PIC32MZ Embedded Connectivity (EC) Family Silicon Errata and Data Sheet Clarification

The PIC32MZ Embedded Connectivity (EC) family of devices that you have received conform functionally to the current Device Data Sheet (DS60001191D), except for the anomalies described in this document.

Data Sheet Clarifications

4.2 System Bus Arbitration

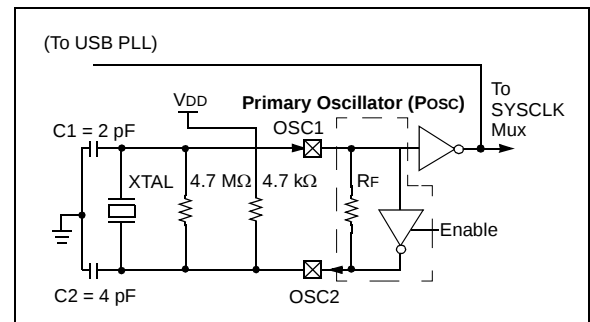
1. Module: System Bus Arbitration
